MIDLAND NUCLEAR UNITS 1 & 2
CANONIE CONSTRUCTION COMPANY

To J. F. Newgen
Subject Midland Plant Units 1 & 2
Job 7220
Moisture Requirements for
Backfill Prior to Placement
Copies to File: 0274

To J.F. Newson
Subject Midland Plant Units 1 & 2
Job 7220
Moisture Control
File: 0224

PLAN OF RAMP AREA
M.T.S.

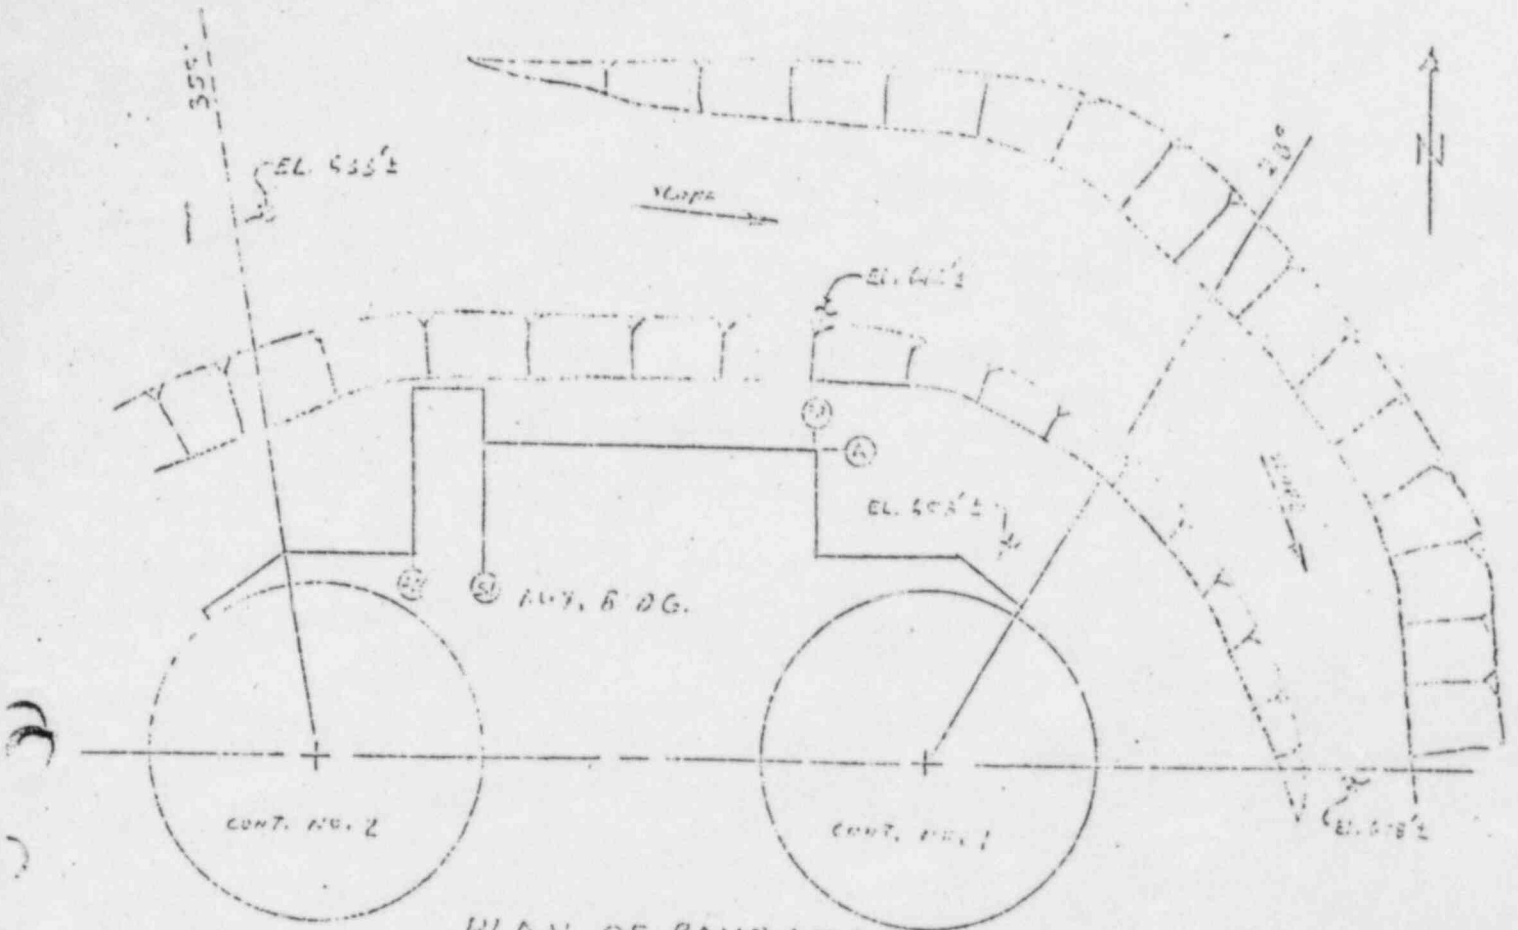
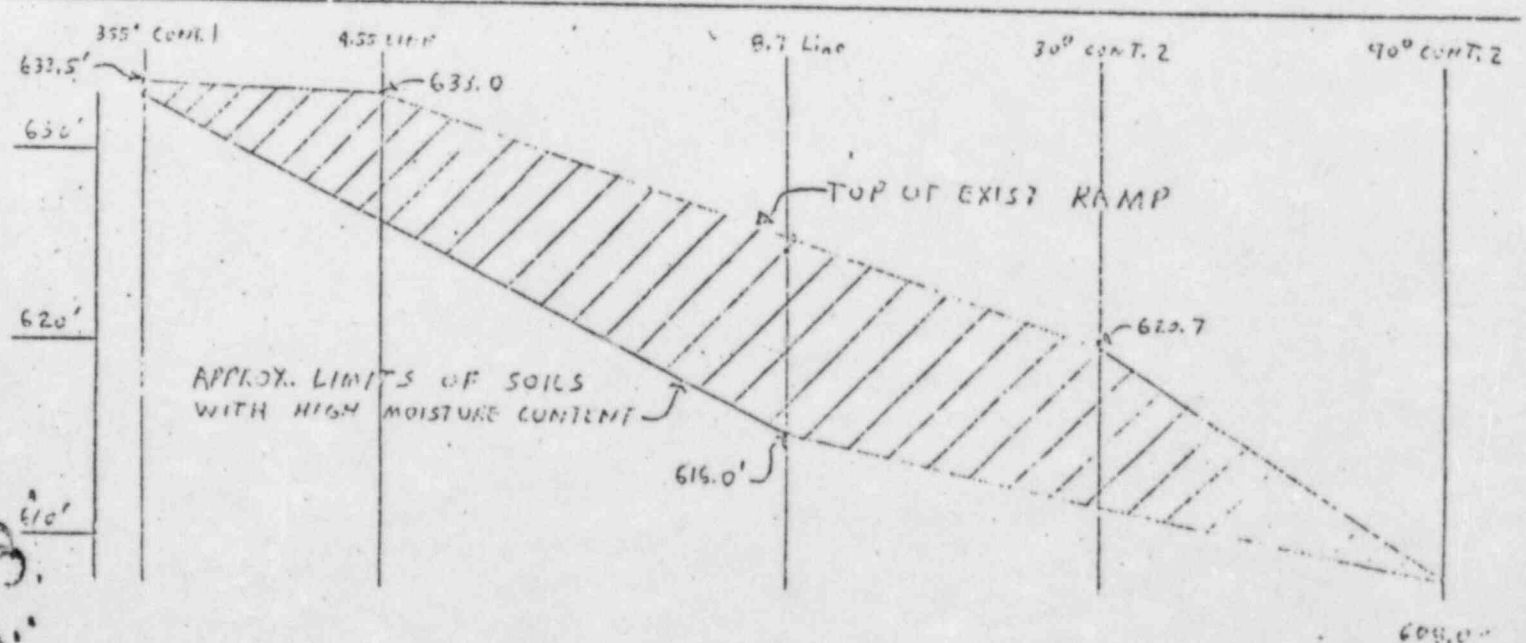
* This area reworked and retested: See test No. MD-514

** Moisture and Compaction pass: clears MD-490 and MD-492

*** This area reworked and retested: See test No. MD-533 for passing compaction

Review of Nonconformance # 421*See (6) Comments*

FIGURE 1

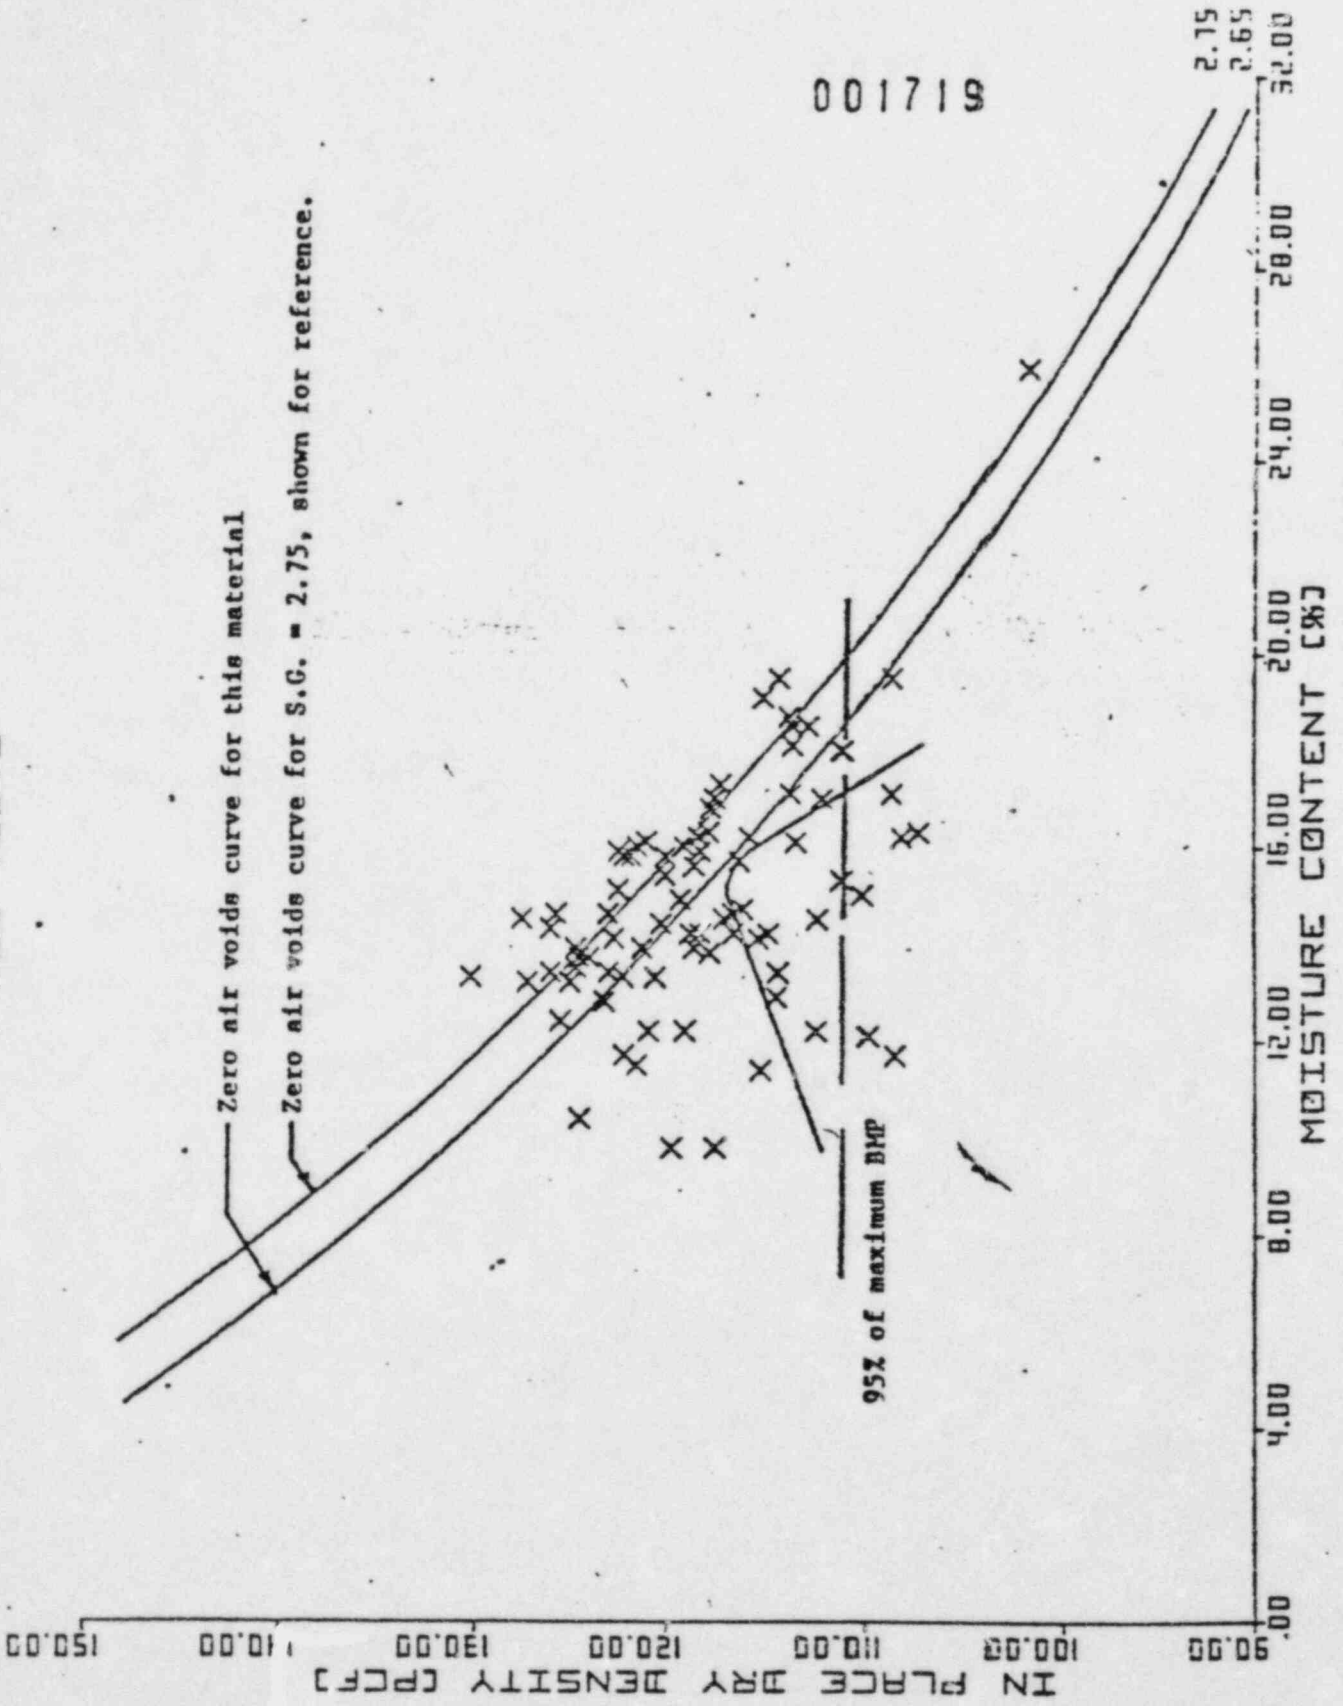
Soils cannot be more than 100 percent saturated; therefore, all field density test data points, when plotted as dry density versus moisture content, must be below the zero air voids curve as defined by the specific gravity of the material. Specifications do not require examination of the zero air voids curve, but it is considered common practice relative to compaction plots. There are numerous cases in the U. S. Testing Company data where points plot above the zero air voids curve. Figure 1 attached shows a typical laboratory compaction test curve with field test results plotted on it. Many of the field test results are to determine percent compaction plot above the zero air voids curve. Provided the specific gravity is correct this is not possible so that all such points must represent erroneous data.

Also, referring to Figure 1 it would appear that soil density varied widely. Specifications called for compactive effort results as defined by ASTM D 1557 which is 56,255 ft-lb/ft³ energy. This was modified to a laboratory test compactive effort of about 20,000 ft-lbs/ft³ energy, often referred to as Bechtel Modified Proctor (BMP). Laboratory compaction test curves should be related to the same effort as that called for in the field for use in comparing with field density tests to determine percent compaction. According to plots of field data shown on Figure 1, density varied from about 108 lb/ft³ to about 130 lb/ft³. It is doubtful that the soil classification or other properties would be similar for such a wide variation in density. It is noted that 100 percent of modified Proctor (ASTM D 1557) which is difficult to obtain, is rated at 56,255 ft-lb/ft³ energy. The curve plotted on Figure 1 is at about 20,000 ft-lb/ft³ energy. For comparative purposes it was determined by U. S. Testing in 1974 that 100 percent of specified effort (20,000 ft-lb/ft³) is approximately equal to 95 percent of the maximum density as determined by ASTM D 1557 (56,255 ft-lb/ft³) Reference Figure 8.

band of specific gravity values represented in the Bechtel report figure 1 results in a 49 percent reduction of theoretically impossible results. The remainder of these test points falling above zero-voids line will be discussed in Section 6. However, specific gravity values from 2.57 to 2.82 for soil fractions are documented for material on this project.

FIGURE 7: WINDOWS OF ACCEPTABILITY (A) BASED ON BMP
 SPECIFICATION (B) REGARDLESS OF EXACT WORDING OF
 SPECIFICATION

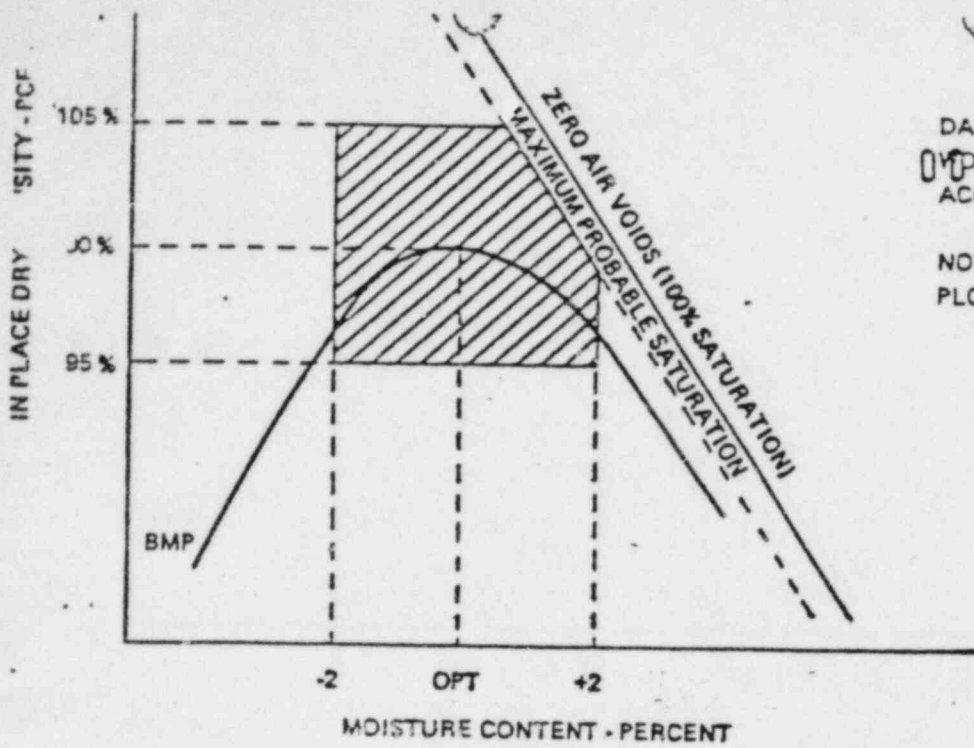
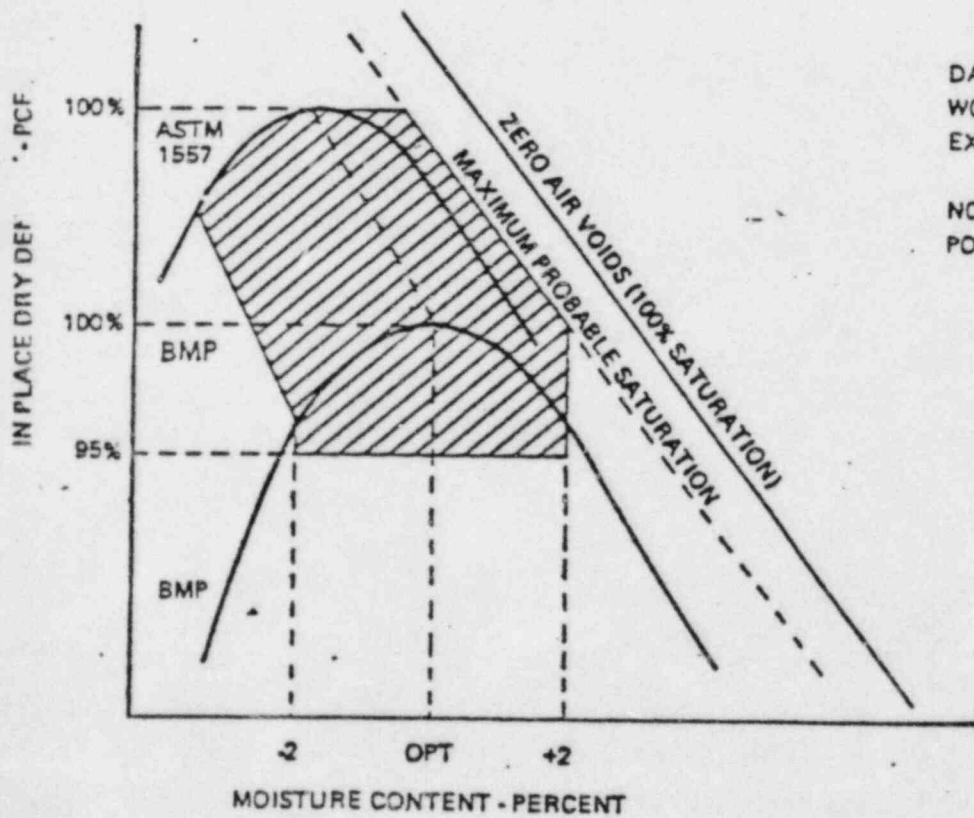
For a field test result to be valid as well as "Passing" it must fall within a well defined area on the plot containing the laboratory compaction curve. This area or window of acceptability is shown for a hypothetical compaction curve on Figure 7a that would meet requirements of Specification 7220-C-210. It is defined by horizontal lines at 95 percent and 105 percent of specified density, vertical lines through ± 2 percent of optimum moisture content, and a line parallel to the zero voids line indicating saturation about half way between the compaction curve and 100 percent saturation (zero air voids curve). The practical upper limit of 105 percent of specified density is not defined in the specifications. It was arbitrarily chosen as numbers greater than this give increasingly invalid comparisons between field test results and the specified laboratory compaction test curve. Therefore, if all data points fall within the defined window there would be no reason to assume that they are wrong. However, when many data points fall outside the designated area there is something wrong with the information and then all data points become suspect. A review of all data indicates that about 25 percent of the cohesive soil test results fall within this area.

Figure 7B shows an area where field test results would be acceptable, in theory even though not in strict accordance with the specifications. Figure 7B was arrived at by expanding Figure 7a to include test results up to a compactive effort related to ASTM D 1557 (56,255 ft-lb/ft²) which is considered to be a practical upper limit. About 40 percent of all cohesive soil test results would plot in this area.

FIGURE 9

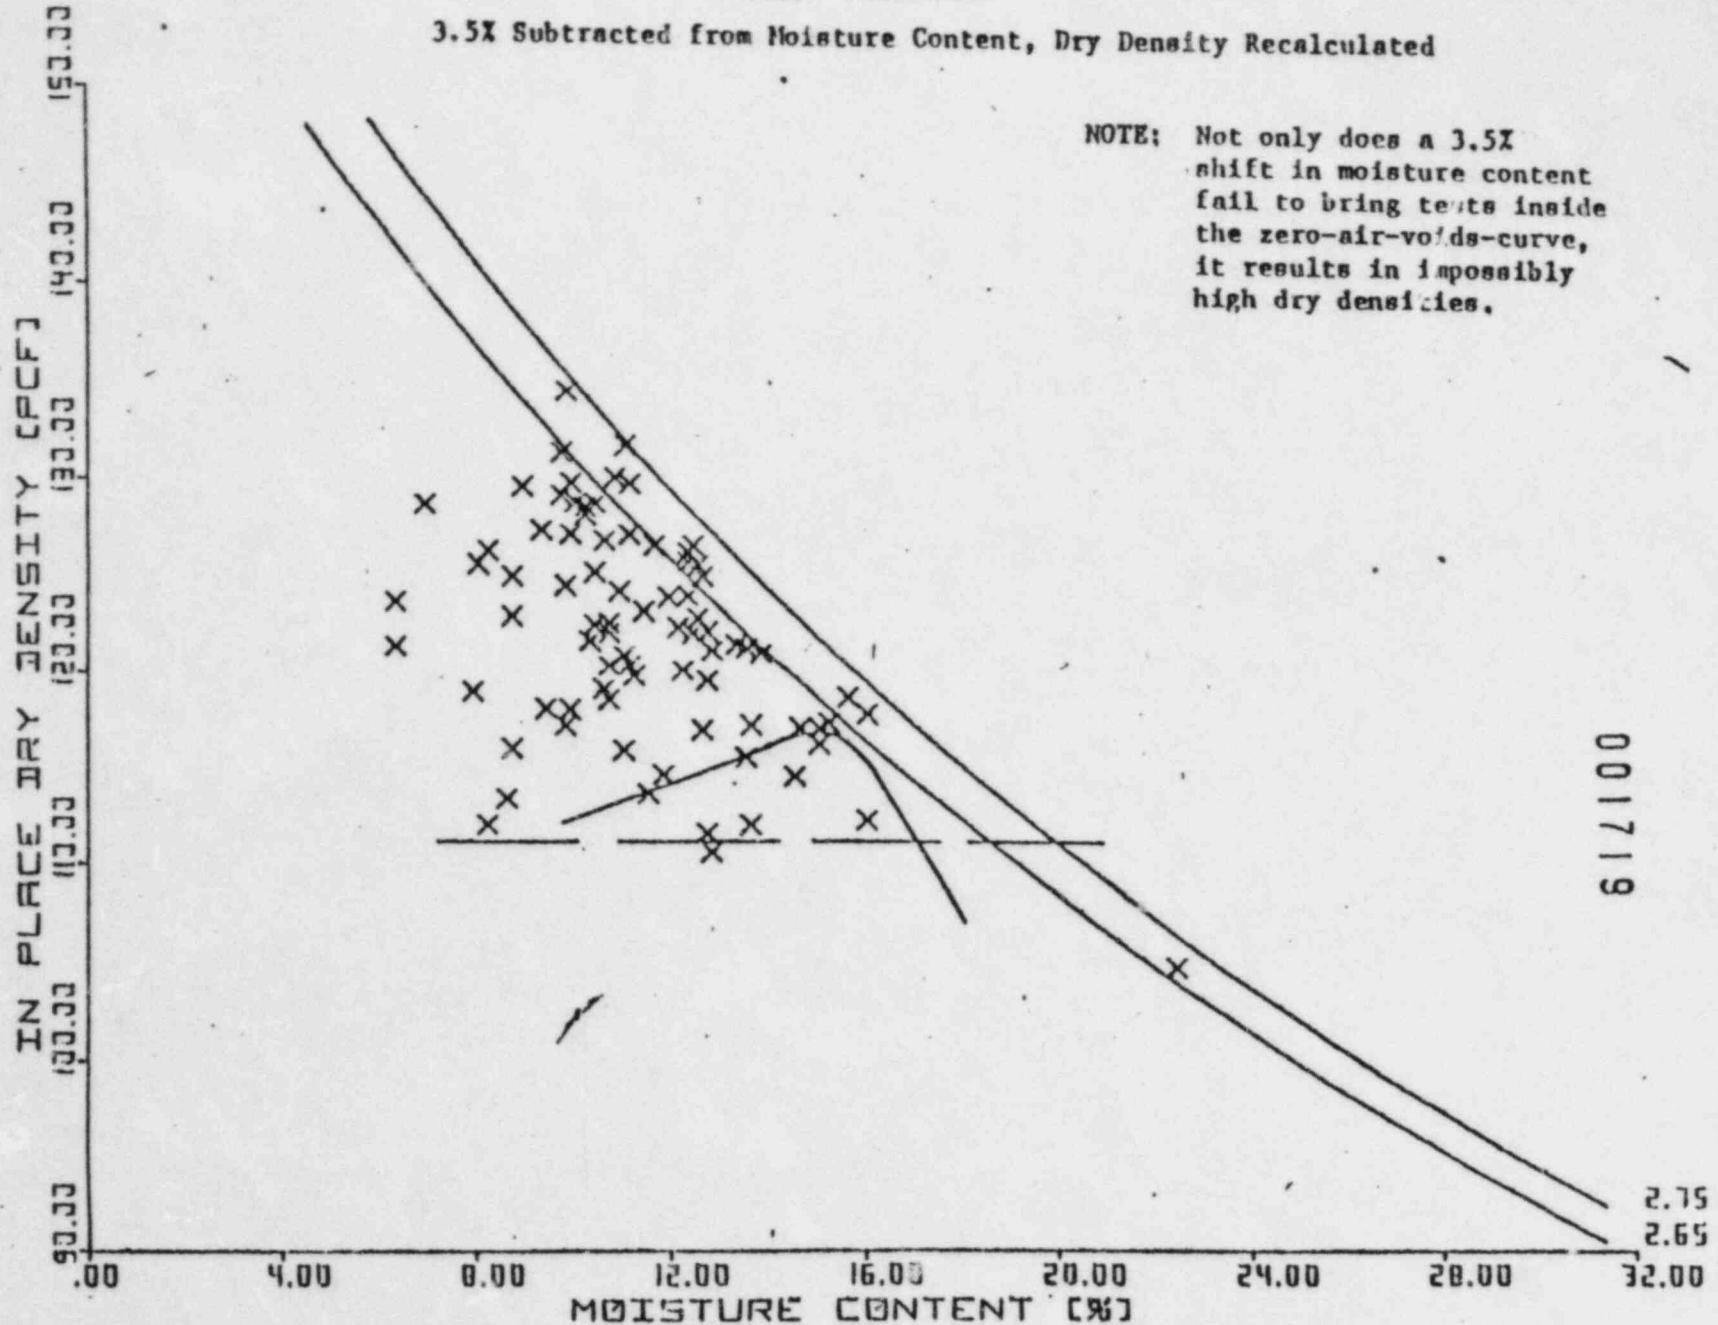
NOTE: Not only does a 3.5% shift in moisture content fail to bring tests inside the zero-air-voids-curve, it results in impossibly high dry densities.

Contrary to the assumption regarding figure 9 with its "impossibly high dry densities" current test data closely resembles this graphical representation.
